UNITED STATES PATENT AND TRADEMARK OFFICE

APPLICATION NO.	FILING DATE	FIRST NAMED INVENTOR	ATTORNEY DOCKET NO.	CONFIRMATION NO.
10/686,507	10/14/2003	Bernard Andreas	021629-001900US	3531
20350 7590 01/06/2009 TOWNSEND AND TOWNSEND AND CREW, LLP TWO EMBARCADERO CENTER EIGHTH FLOOR SAN FRANCISCO, CA 94111-3834				
EXAMINER				
OU, JING RUI				
ART UNIT		PAPER NUMBER		
3773				
MAIL DATE		DELIVERY MODE		
01/06/2009		PAPER

Office Action Summary

DETAILED ACTION

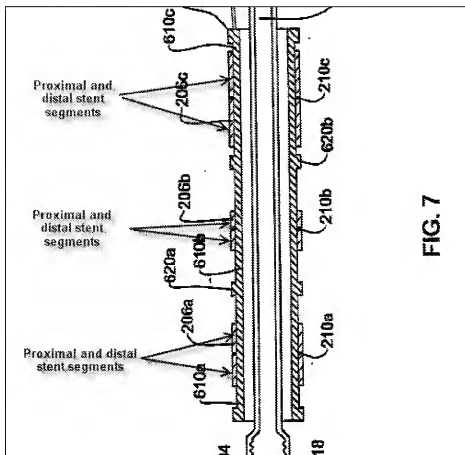
In regard to claim 1-2, 5-12, 15-18 and 20, Chermoni discloses:

A) a stent delivery device for delivering a plurality of stent segments to a treatment site, the device comprising: a catheter shaft (124, Fig. 1) having a proximal end and a distal end; an expandable member (balloon, 104, Fig. 7) coupled with the catheter shaft near the distal end; a shuttle (carriage, 605, Fig. 7) disposed coaxially over at least part of the catheter shaft and the expandable member, at least part of the shuttle being radially expandable (Para. [0042]); and a plurality of stent segments (distal and proximal segments of stents 206a, 206b, and 206c, Fig. 7 and see Figure below or Para.[0004]) having a radially collapsed configuration and a radially expanded configuration, the stent segments disposed along the shuttle and advanceable therealong such that adjacent stent segments may be advanced along the shuttle into direct engagement with one another in the collapsed configuration (the distal and proximal segments of stent 206a, 206b, or 206c are adjacent to each other and are in direct engagement with one another in the collapsed configuration. They are capable to advance along the shuttle);

B) the shuttle is slidably disposed over at least part of the catheter shaft and the expandable member (Para. [0041]);

C) the stent segments are fixed to the shuttle until they are expanded into a deployed position (Paras.[0041]-[0042]);

D) the stent segments are slidable (Para.[0041]), the device further comprising a stent-pushing member (106, Fig. 7), proximal to the plurality of stent segments.

E) the shuttle further comprises an abutment (barrier, next to 610a, Fig. 7) at or near a distal end of the shuttle for preventing the plurality of stent segments from being advanced beyond the distal end of the shuttle;
